CITY OF NEWTON, MASSACHUSETTS PURCHASING DEPARTMENT

ADDENDUM #2 INVITATION FOR BID #24-01

GATH MEMORIAL POOL IMPROVEMENTS PROJECT

THIS ADDENDUM IS TO: CHANGE PROJECT MANUAL AND MAKE DRAWINGS CHANGES.

POOL DETAILS 2

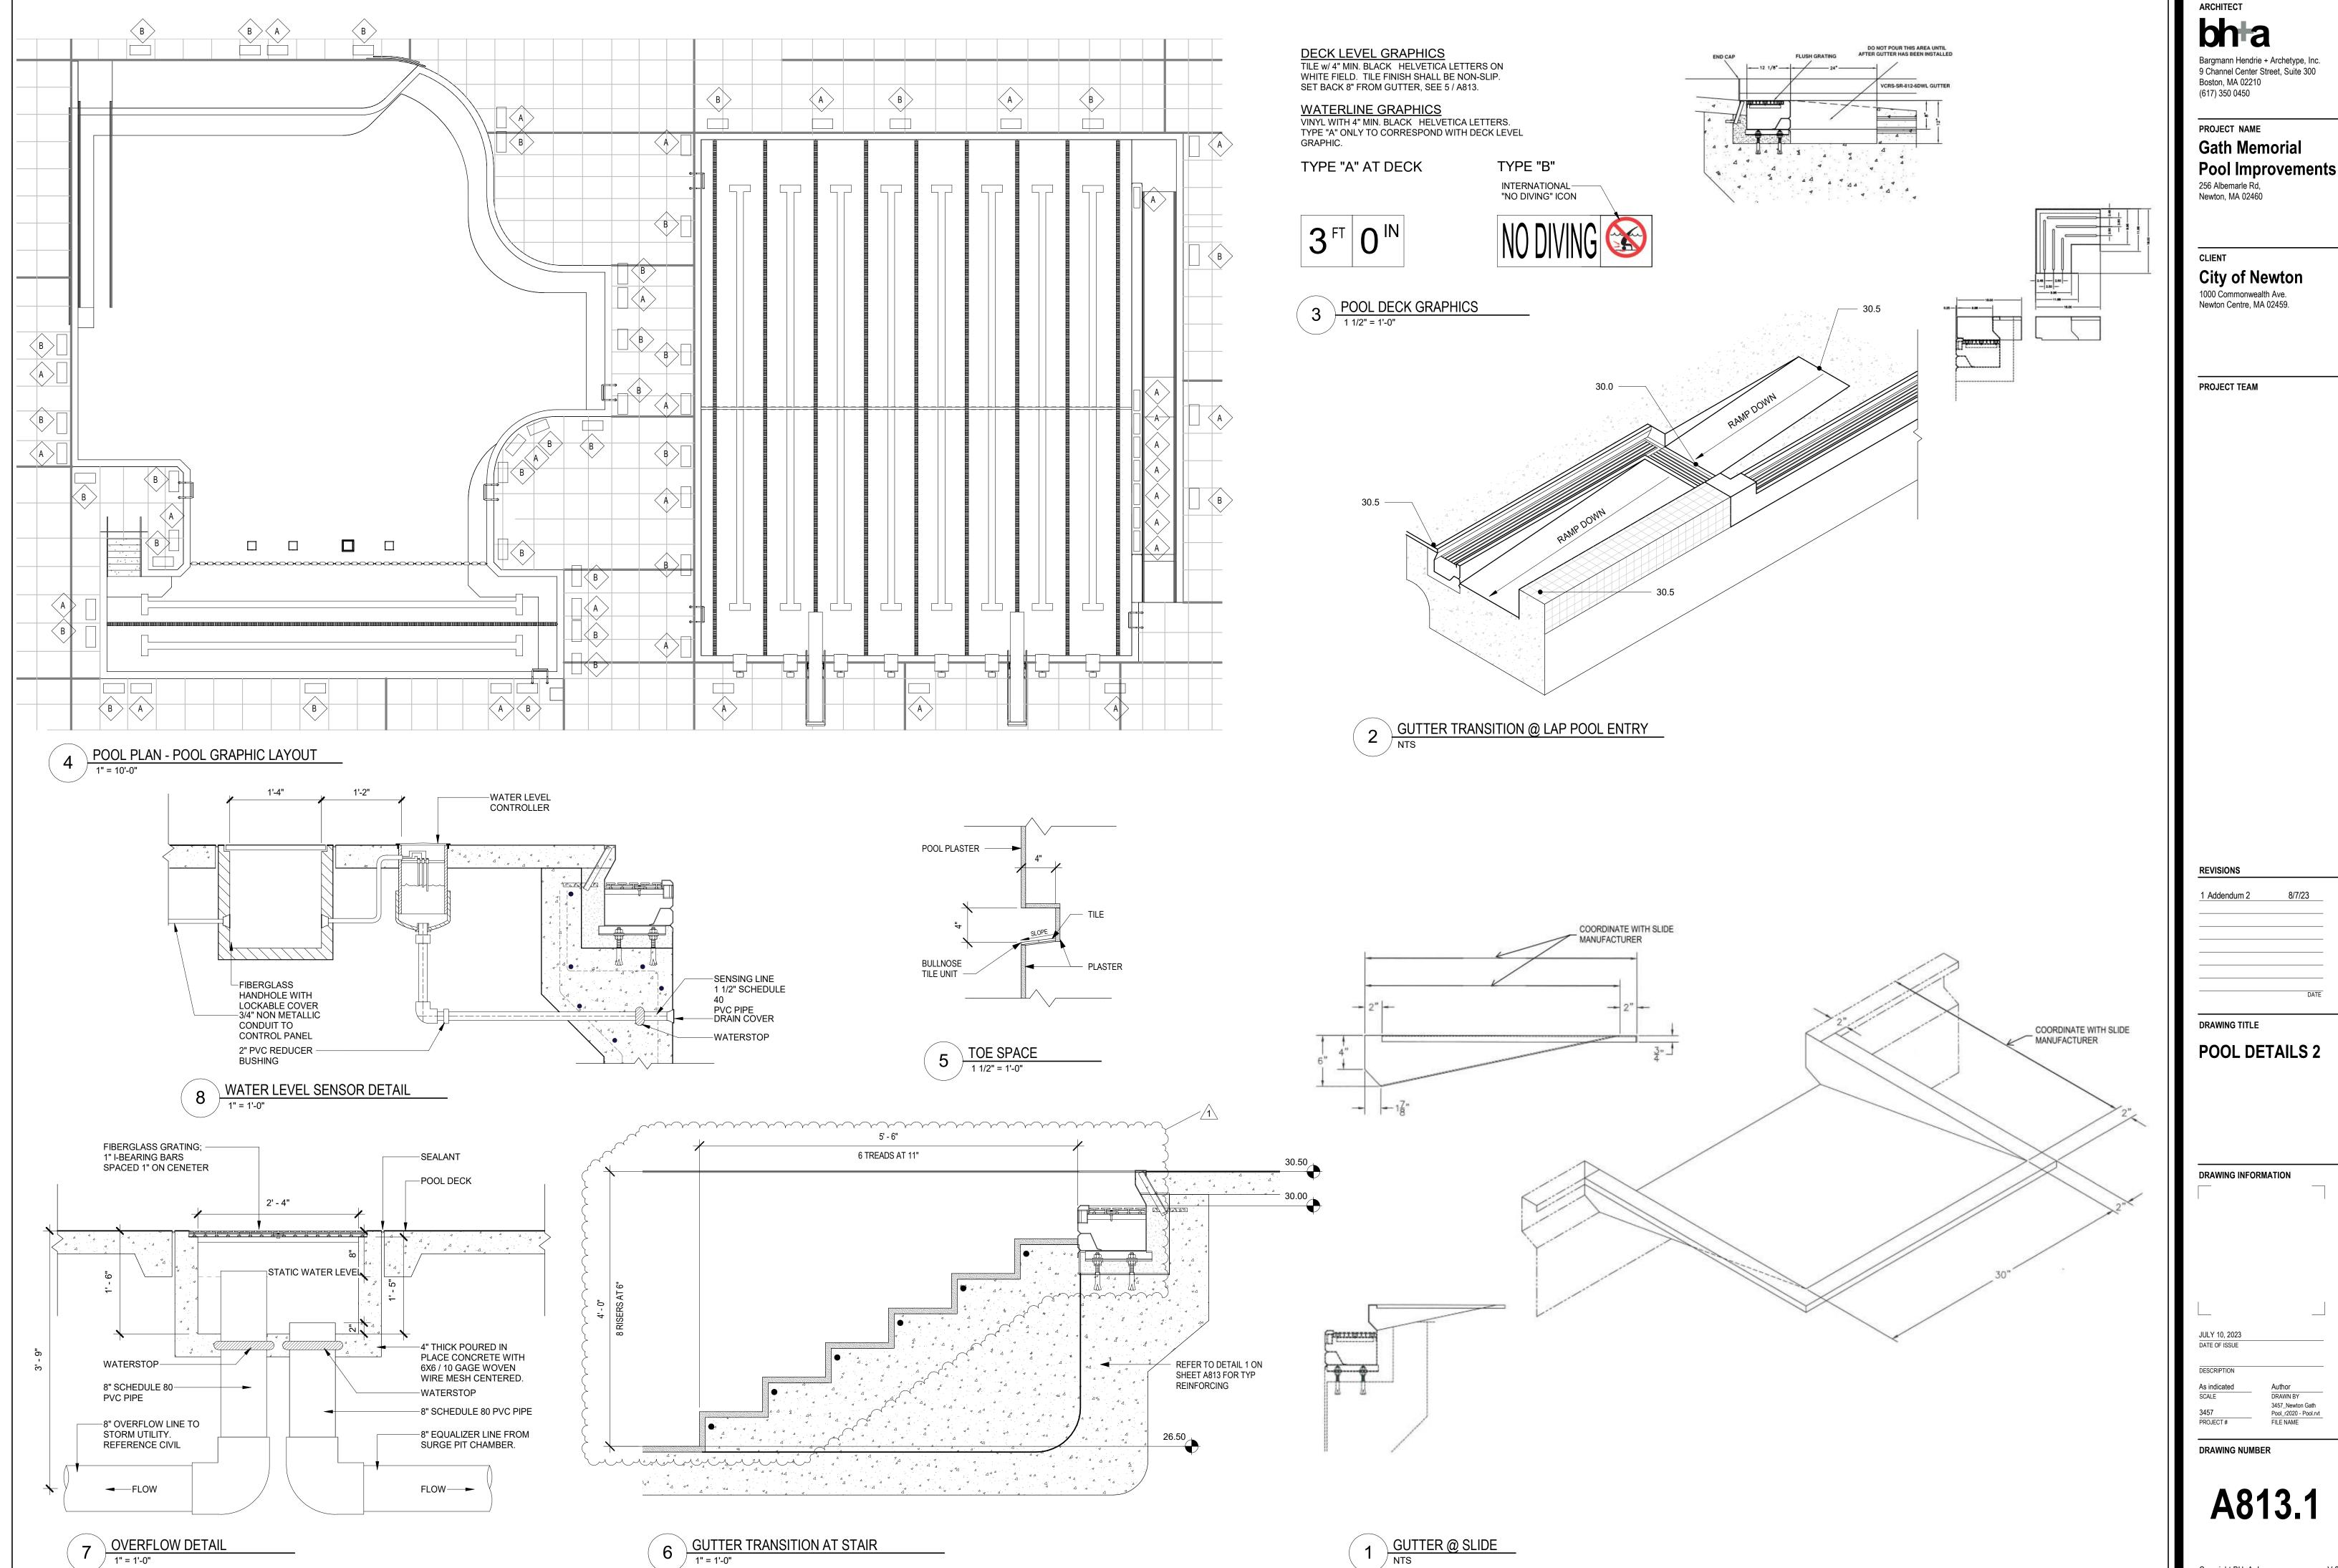
• Remove and insert revised Sheet A813.1

Scope: Correction of gutter at stair to show 8 inch gutter, correct risers, Detail 6.
